NUCLEAR REGULATORY COMMISSION

Title: Advisory Committee on Reactor Safeguards
 US-APWR Subcommittee

Date: Wednesday, November 20, 2013

SRP3.3.1
(ASCE 07-05)

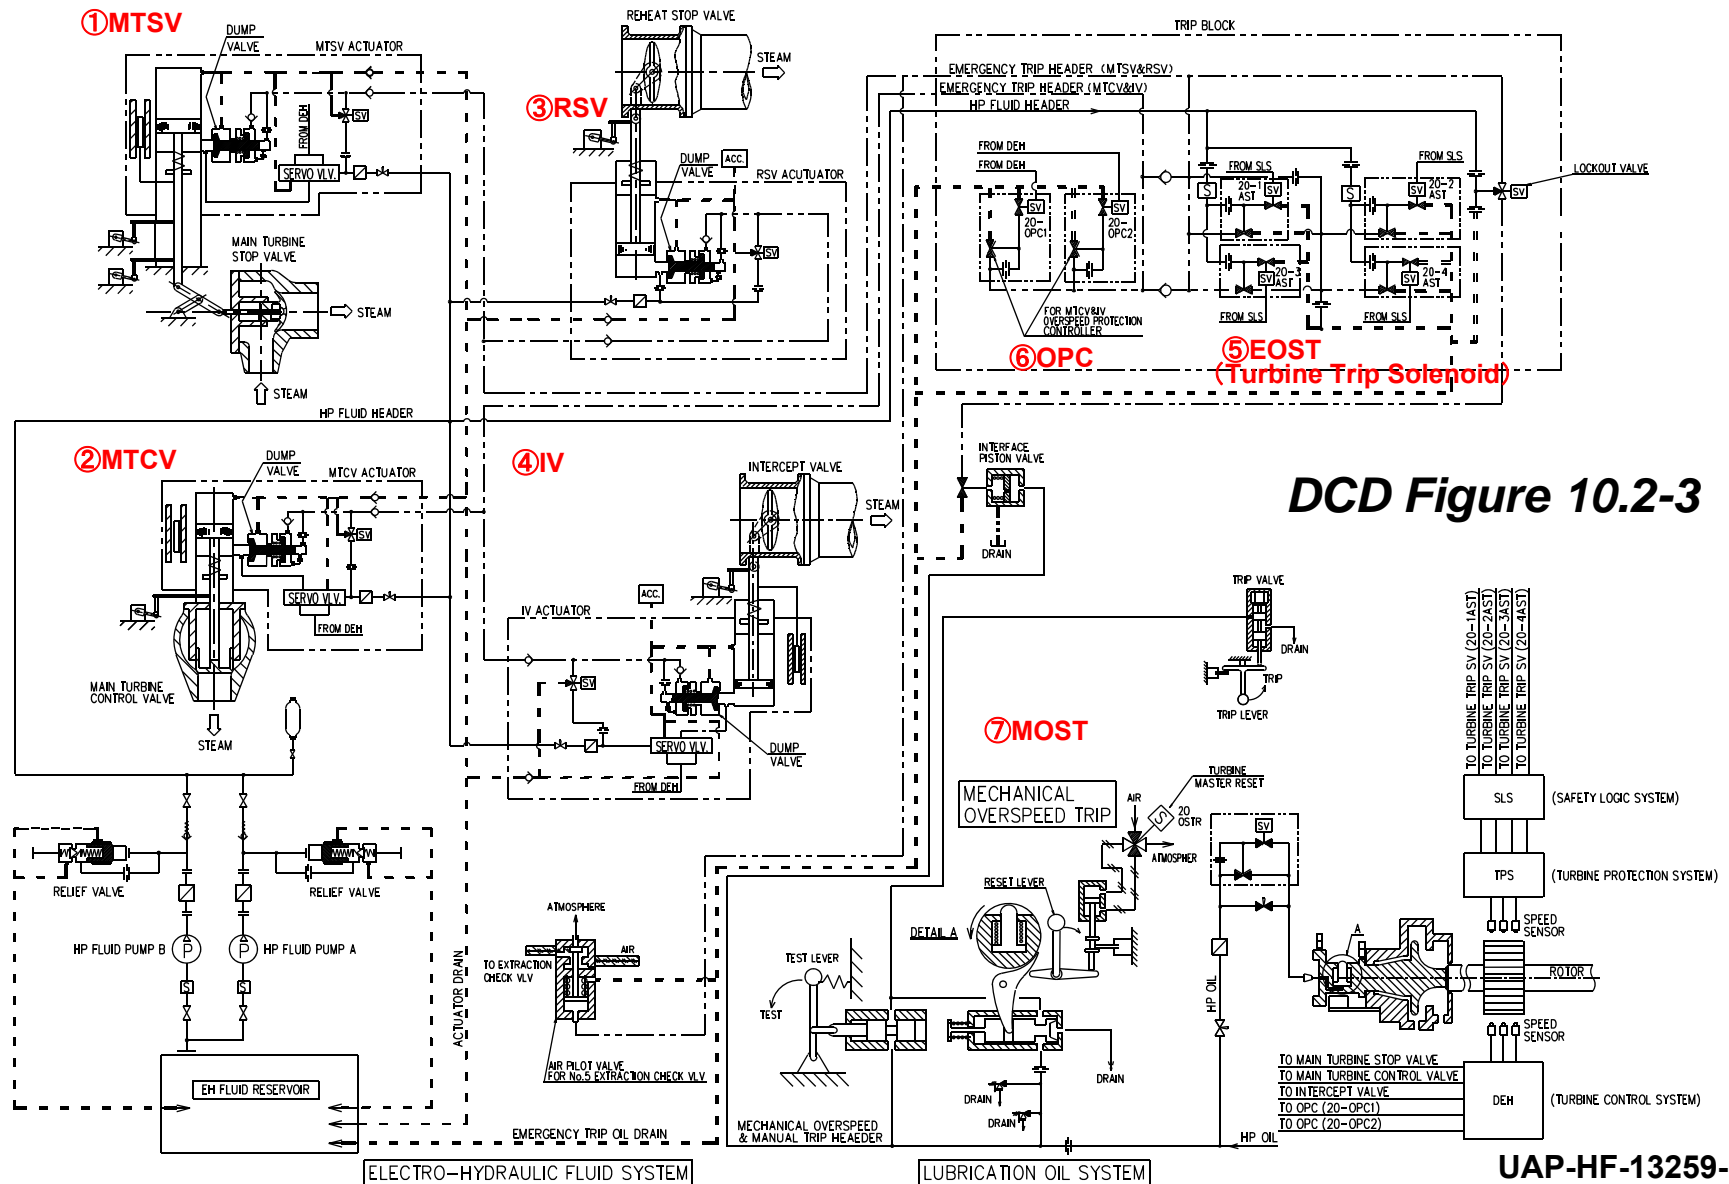
20 MEMBER RICCARDELLA: Well, no, my question
21 is specifically about Section 3.3 of the 07028 Report.

8 MR. OGASAWARA: Could you show the
9 presentation, Page 30? One hundred fifty-five is the
10 probability of ten to the minus two per year. This is
11 a severe wind and 160 miles per hour is a ten to the minus
12 six, that is extreme wind and in our DCD we call it as
13 hurricane.

3 If in the site conditions the winds are
4 higher than 155 or the number is higher than 160, the COL
5 applicant have to show, has the responsibility for the
6 design.
